DEVELOPMENT REVIEW BOARD  
**SUPPLEMENTAL SUBMITTAL**

PROJECT NO. 2020-004475  
Application No. SI-2021-00254

SUBMITTAL  
DESCRIPTION: Dental office for Pino Periodontics. This submittal includes the responses to the staff comments from the DRB hearing 4-14-21.

**RE: Pino Periodontics dental office development at 7413 Holly Ave NE.**

SITE PLAN  
SITE DETAILS  
revisions  
\* DRB COMMENTS ADDRESSED 4-7-21  
\* DRB COMMENTS ADDRESSED 4-14-21

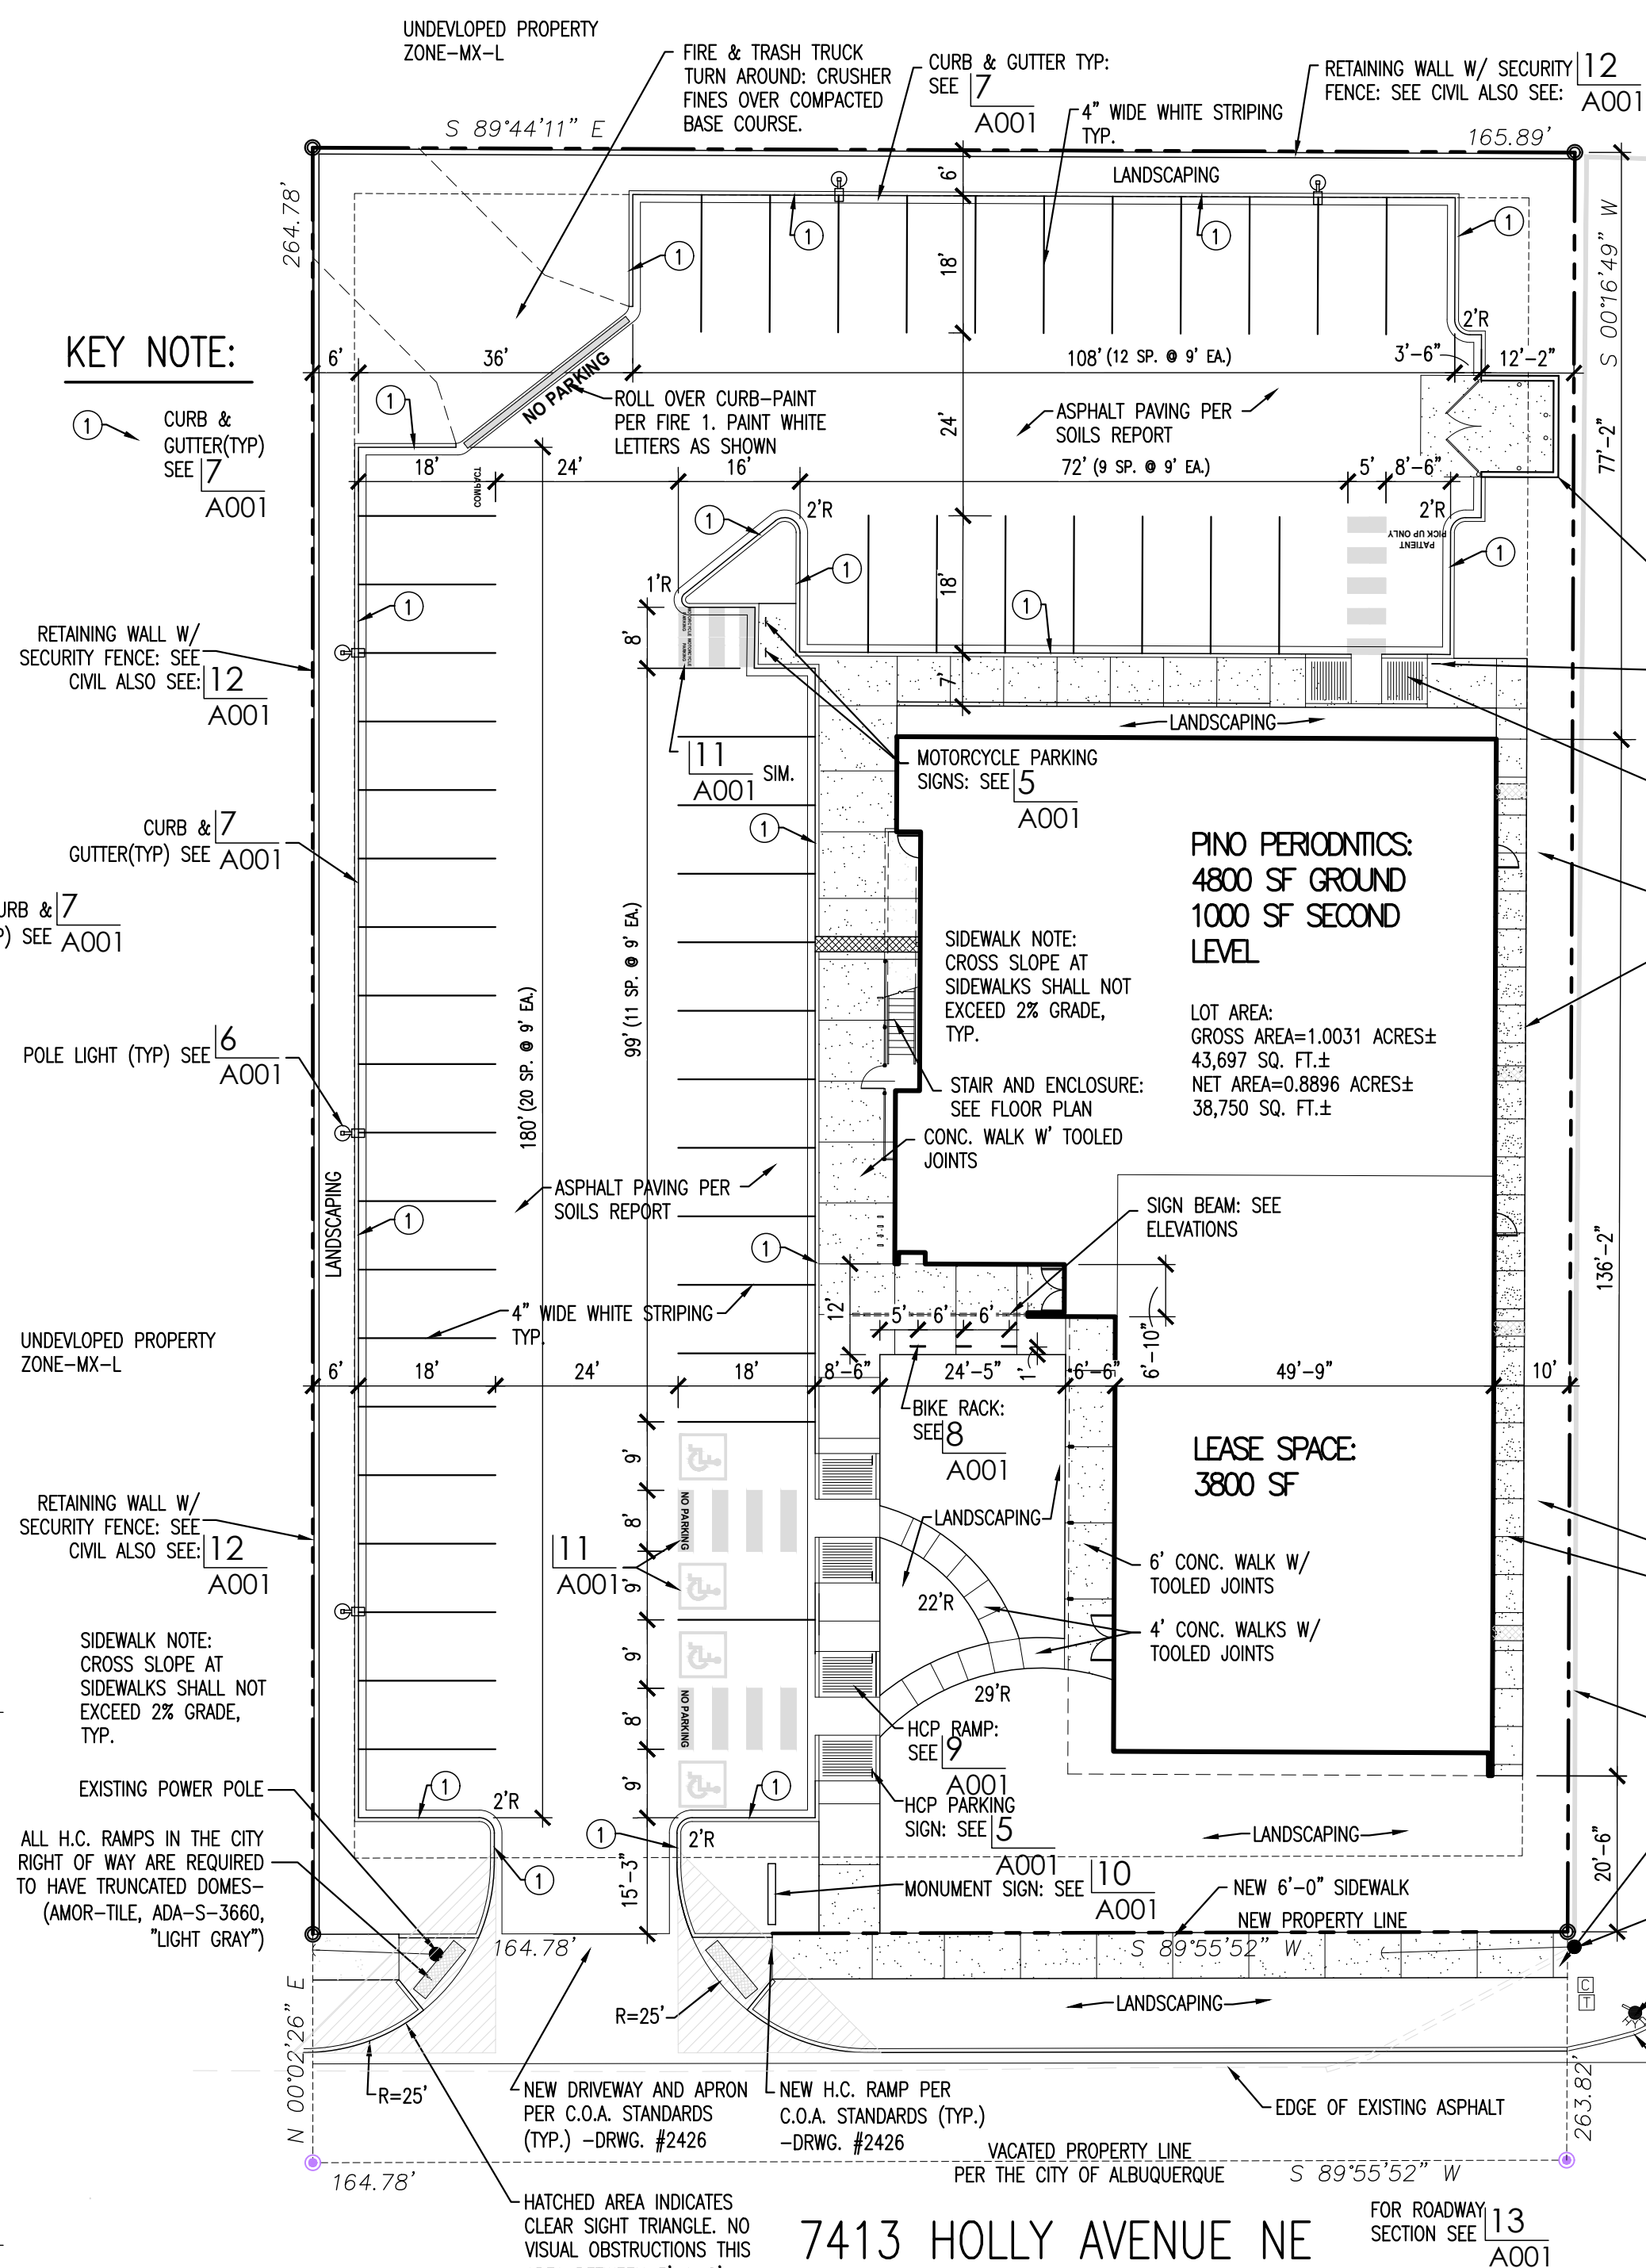
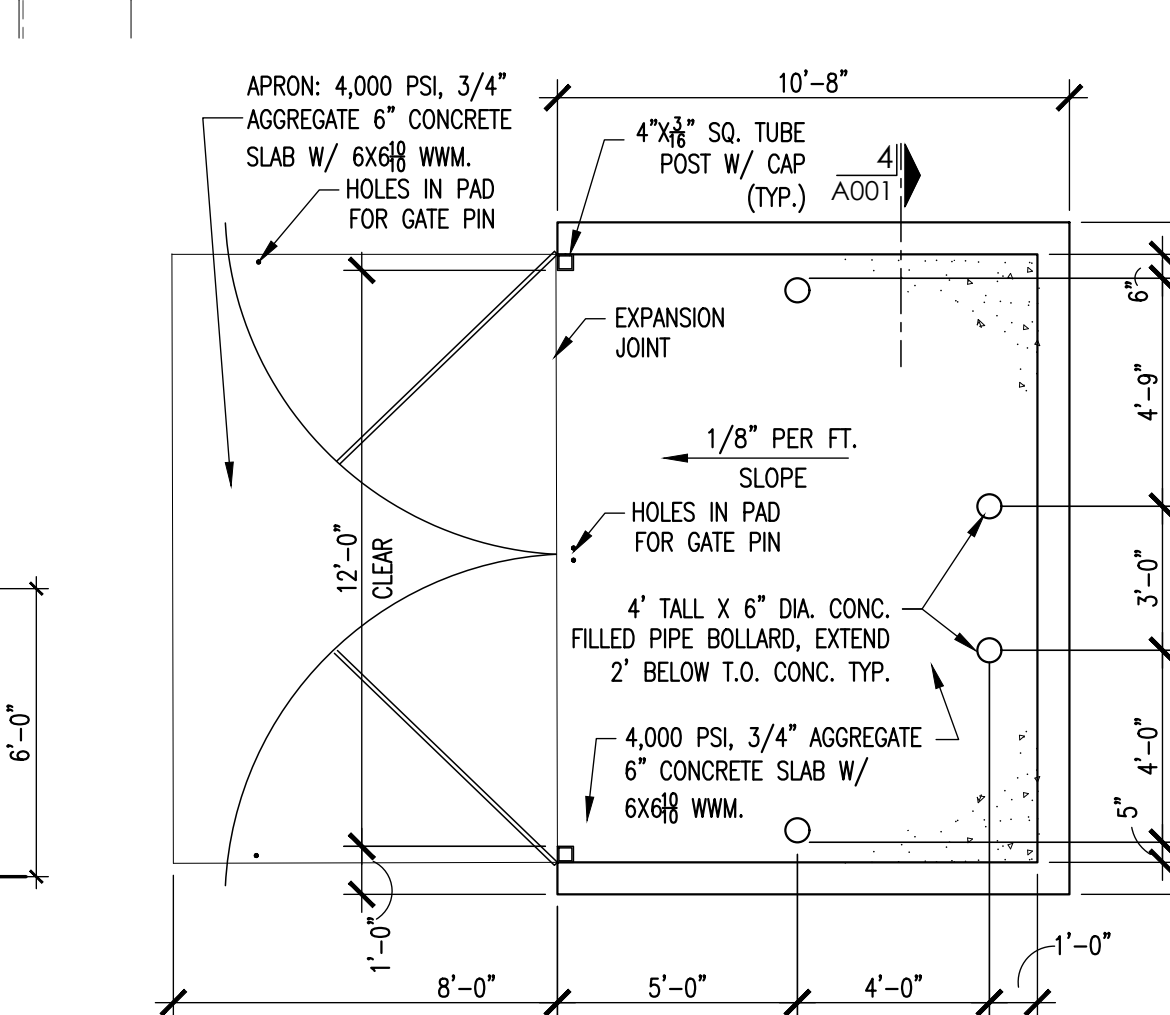
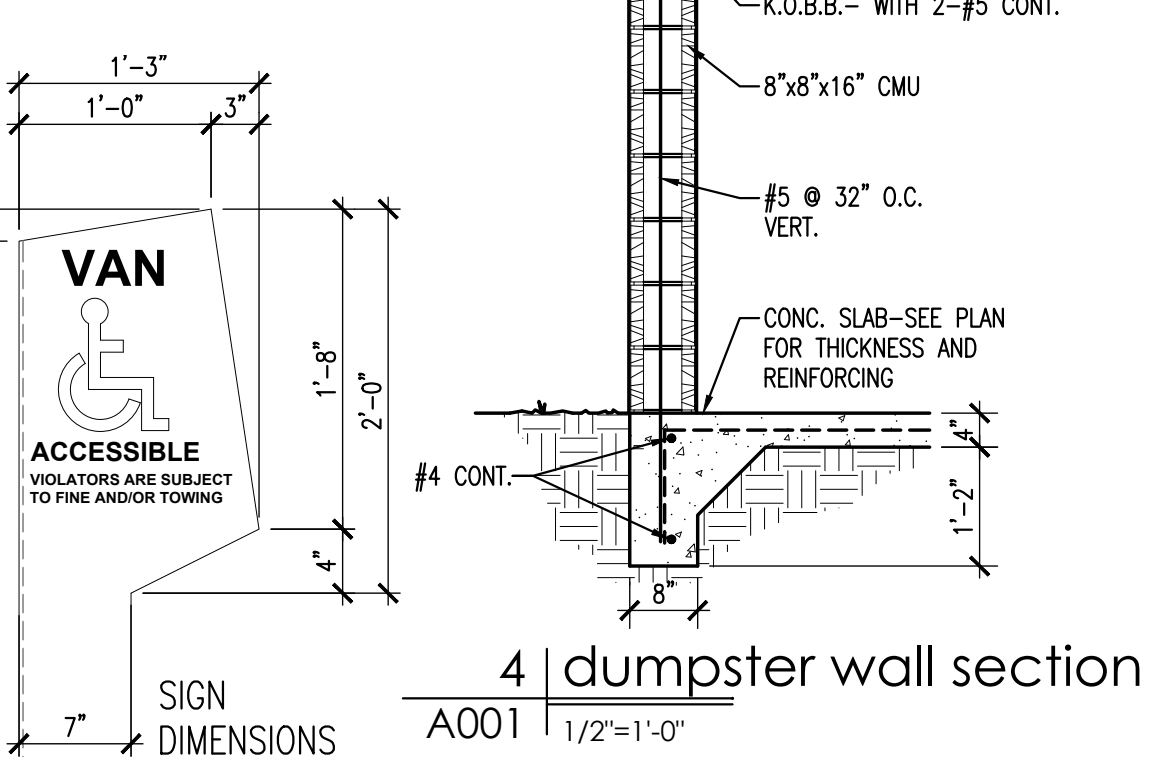
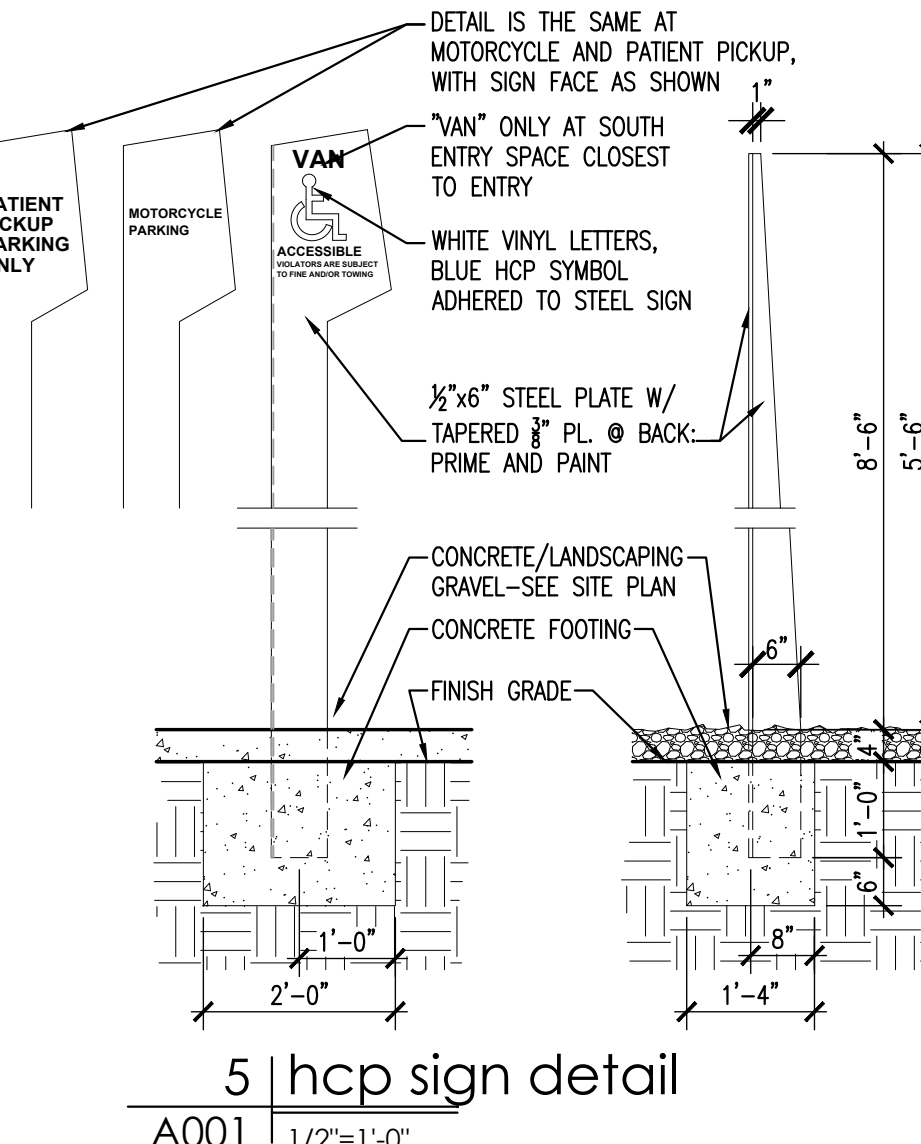
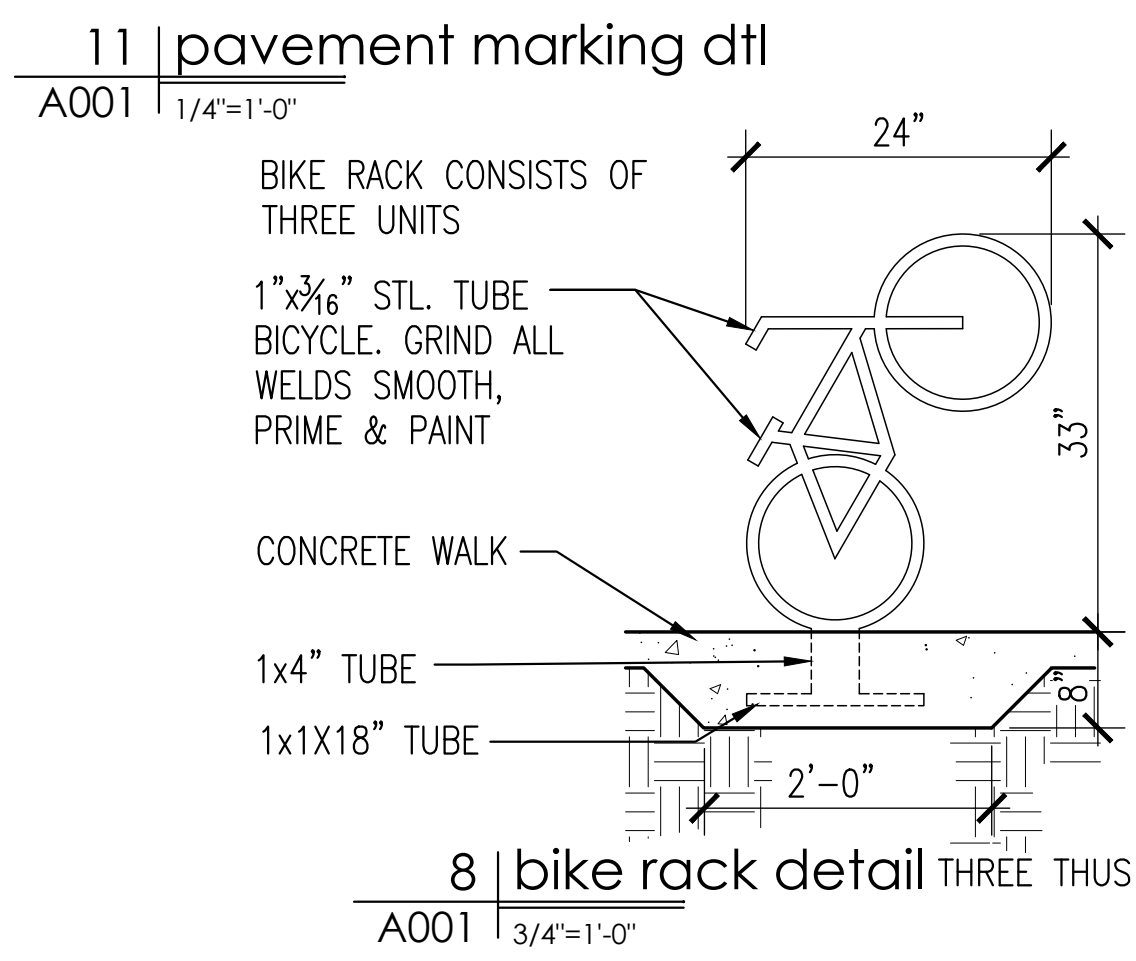
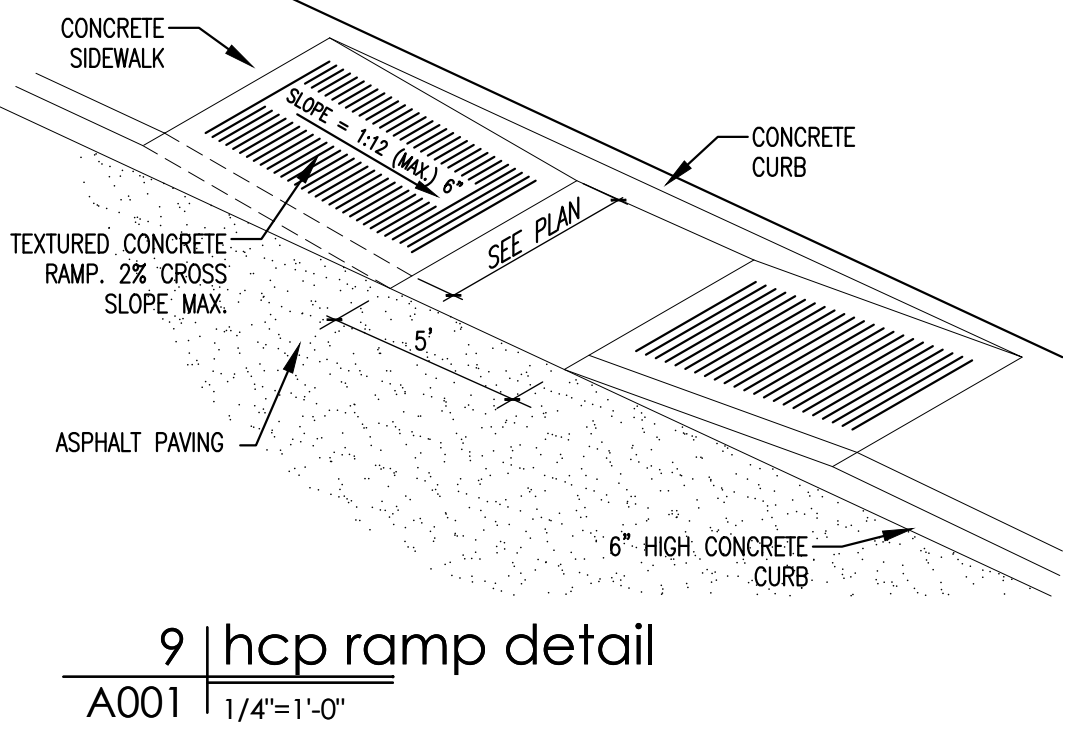
1. Label all on-site curb.
2. Match minimum required dimensions for bike rack per the IDO. Bike rack locations should be kept out of sidewalk to avoid obstruction of the pathway. (Bicycle spaces are 6 feet long and 2 feet wide. Rack dimensions are minimum 30" tall by 18" wide.)

3. Provide a minimum 6-foot pathways from building to handicapped spaces and from right-of-way to building. (This comment now only applies to the ramps. The ramps shown should extend to the full width of the sidewalk to not only accommodate the 6-foot pathway but to avoid a tripping hazard and minimize conflict with the handicapped signage. Adjust walkways to leave space to make sure there is a clear ADA pathway from ramps as necessary.)

4. All curb ramps need a minimum of a 4-ft by 4-ft turning space at the top of the ramp. Provide additional sidewalk width and dimension or revise curb ramp type. (This comment now only applies to the ramp at the north side of the site. Also, there is not a detail for this ramp configuration. The reference calls out the curb.)

5. Provide signed TIS form with the application submittal.
6. For the curb on the street, add "8" standard" to the 2415-A reference.

1. **Label on site curbs:** Keyed note 1 has been added to the site plan and indicated at on site curb and gutter locations.
2. **Bike rack requirements and clearances:** The bike rack has been relocated and redesigned per the requirements of the DPM.
3. **6' pathway to HCP parking spaces:** the hcp ramps have all been modified to comply with accessibility code.
4. **4x4 turning at top of ramp.** This applies to the ramp at the north side of the building which has been redesigned to match the other two ramps.
5. **Provide signed TIS form:** Signed TIS form is attached as part of this submittal.
6. **Add "8 standard" to the 2425-A reference.** This note has been added to street section.
